SERVICE PROCEDURE

G-11519
SEPTEMBER 2011

SUBJECT: SAFETY RECALL
ALTERNATOR WIRING on certain BE and CE non school bus model buses built 6/27/06 thru 3/23/11 with a MaxxFace 7 engine feature code 12NTH, 12NTD, 12NTE, 12NTG, 12VYY, or 12627 and alternator feature code 0008GGR, 0008GGM, 0008GWX, or 0008GEL.

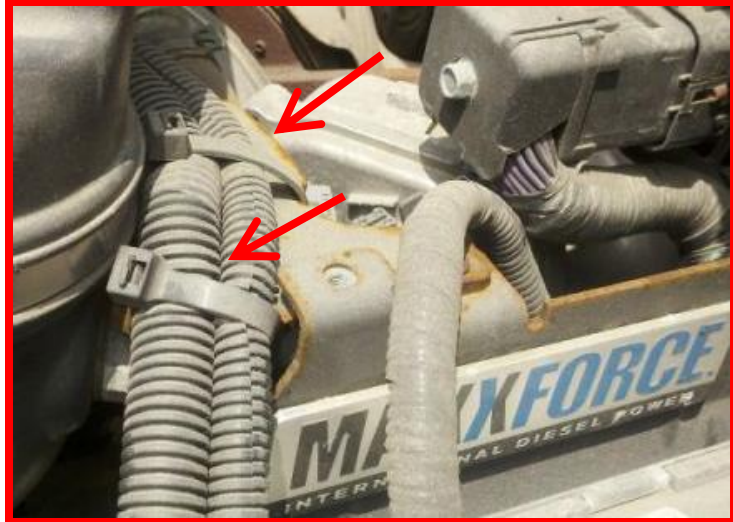
The positive alternator cable may rub on the engine control module mounting bracket possibly compromising its insulation causing an electrical short. An electrical short may cause a fire possibly resulting in property damage, personal injury, or death.

1. Inspect and determine if the alternator cables are properly tie strapped to the engine control module mounting bracket. If so, service procedure is complete.

2. If cables are not properly tie strapped to the bracket determine if the insulation on either alternator cable is damaged due to rubbing on the engine control module mounting bracket. Repair the alternator cable insulation with heat shrink sleeve as necessary.

- Tie strap the alternator cables to the engine control module mounting bracket.
